ADDENDUM # 4

Project	TA Blakelock High School Renovations	Project No.	2215-C
Location	1160 Rebecca Street, Oakville, ON	Date of Issue	2025 05 02
Owner	Halton District School Board	File	2215/7.1.3

This Addendum forms part of the Contract Documents and amends the original Drawings and Specifications, dated 2025 04 17, and all preceding Addenda, as noted below.

- ## DRAWING NOTES
- 1 EXISTING DUCTWORK CONTINUES DOWN TO FLOOR BELOW.
 - 2 EXISTING RADIANT HEATER TO REMAIN.
 - 3 REFRIGERANT PIPE DROPS DOWN FROM ROOF ABOVE TO LEVEL BELOW CONCEALED WITHIN FURRED OUT WALL.

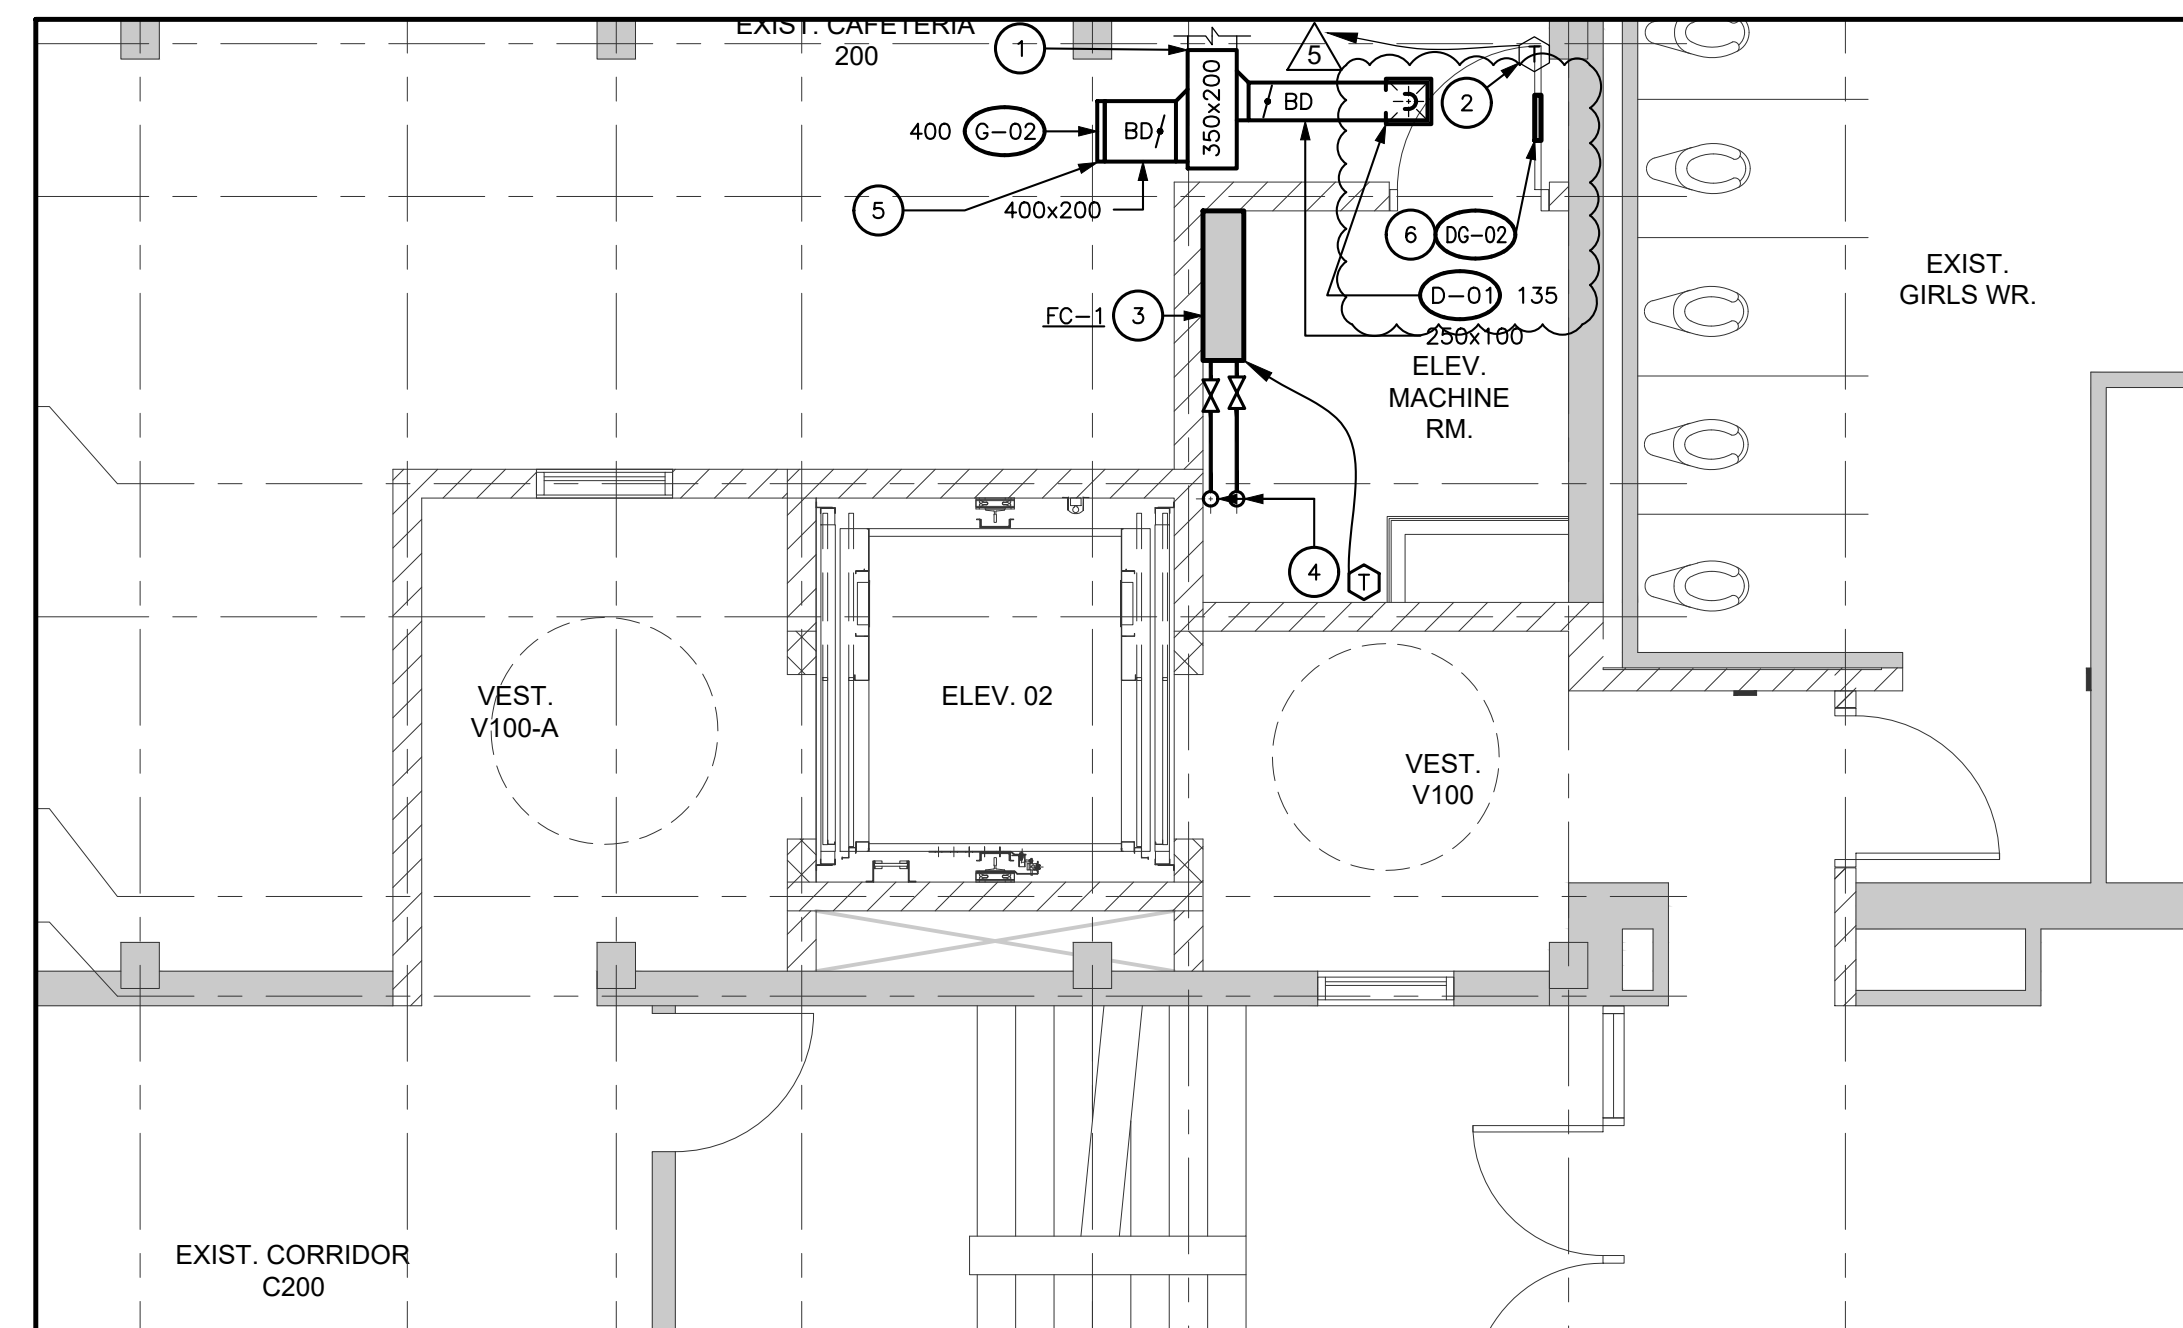
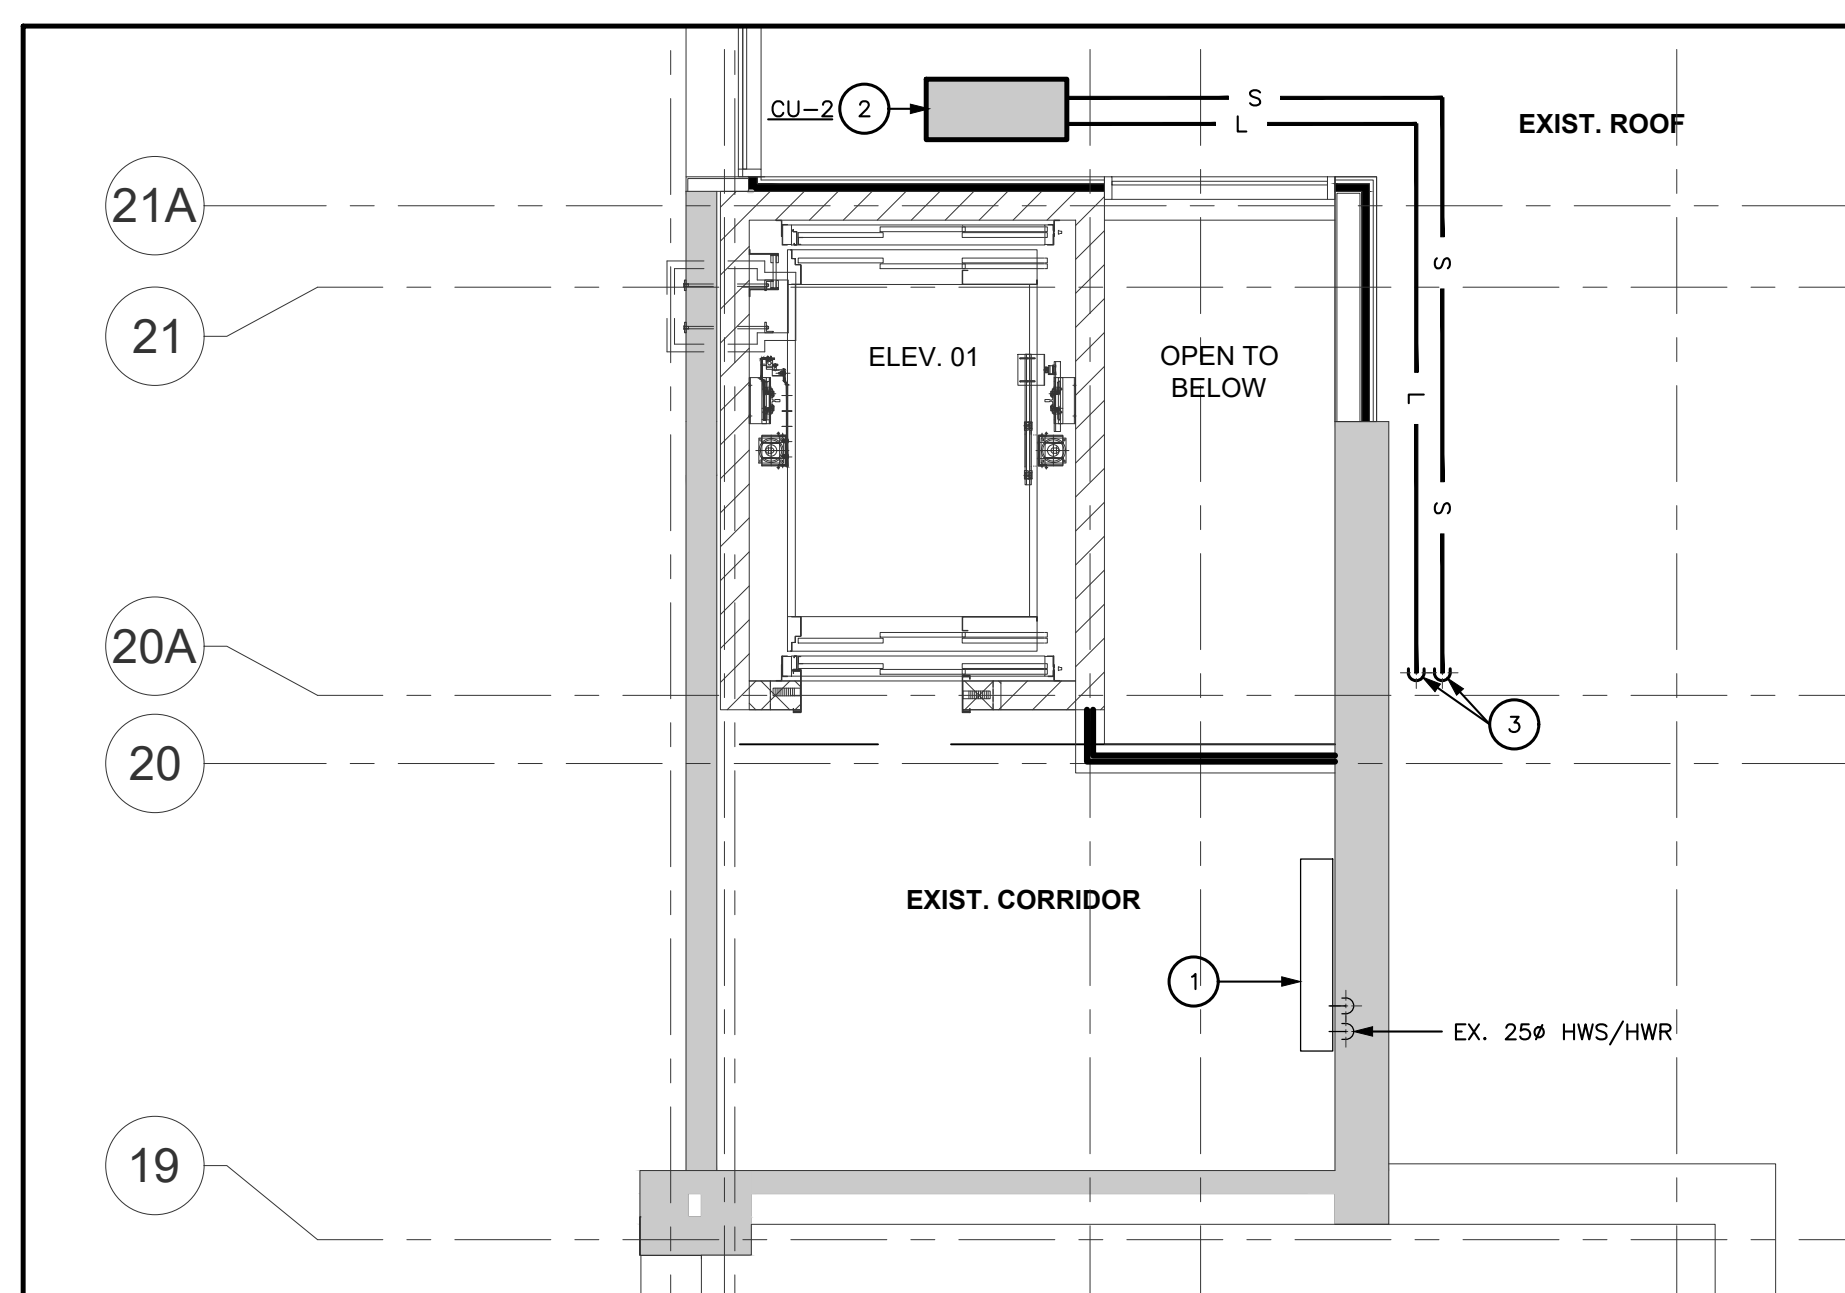
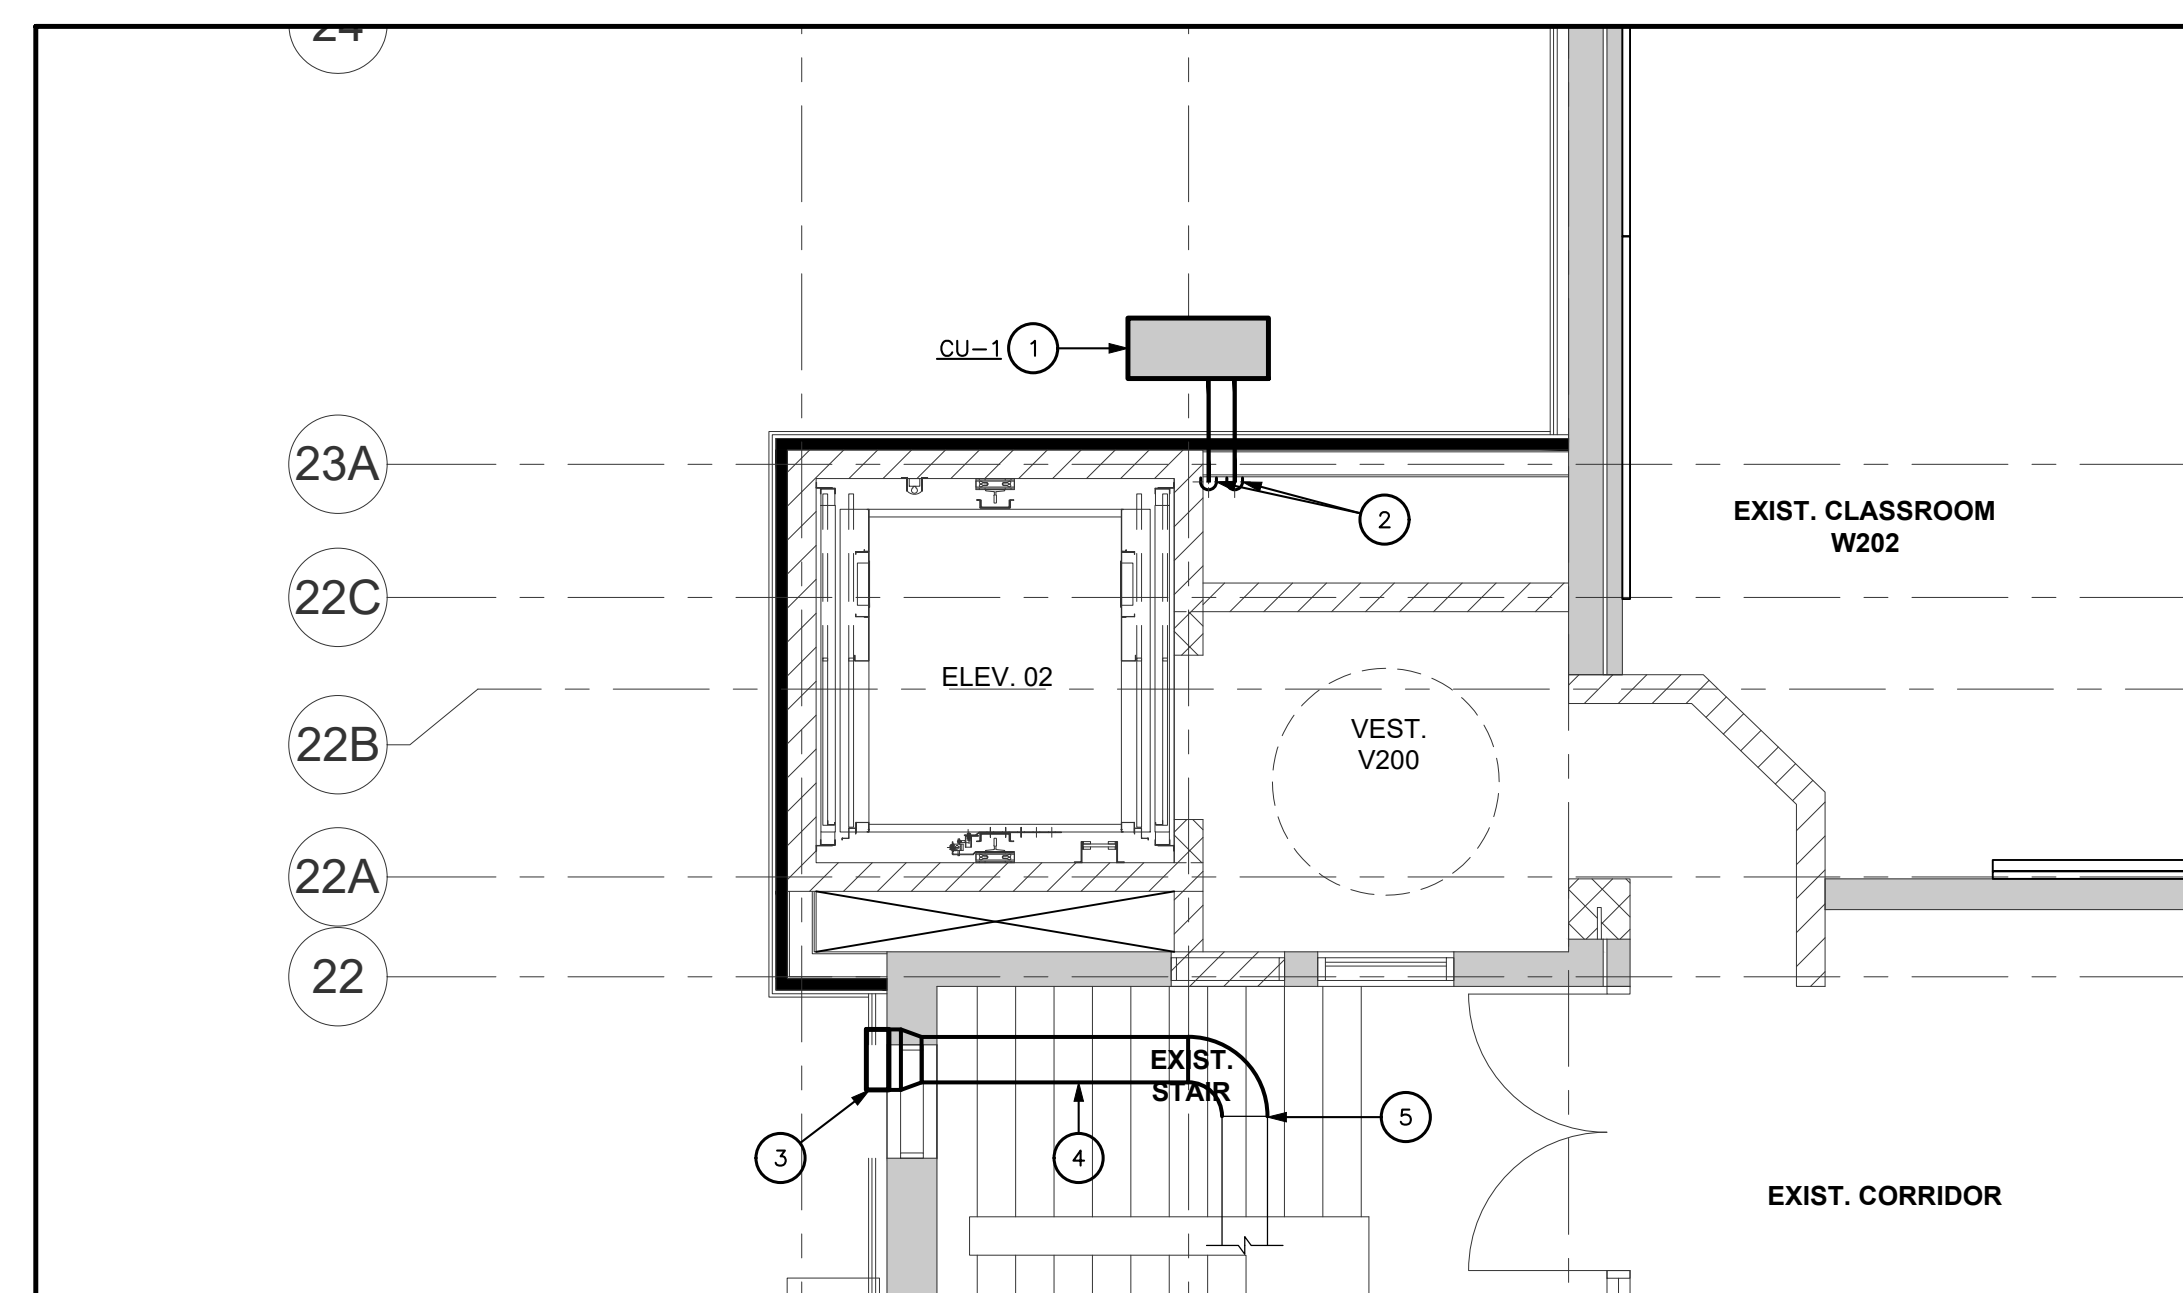
- .2 **Refer to Partial Level 0 Elevator 02 – Demolition Plumbing Plan:**
 - .1 **ADD** demolition of existing sink within millwork to be demolished.
2. **Drawing M300 – LIBRARY WASHROOM AND ELEVATORS NEW HVAC PLANS**

- .1 **ADD** Fire rated transfer grille to new door.
3. **Drawing M400 – MECHANICAL DETAILS AND SCHEDULES**
 - .1 Drawing is issued with this addendum. Modifications include, but are not limited to the following:
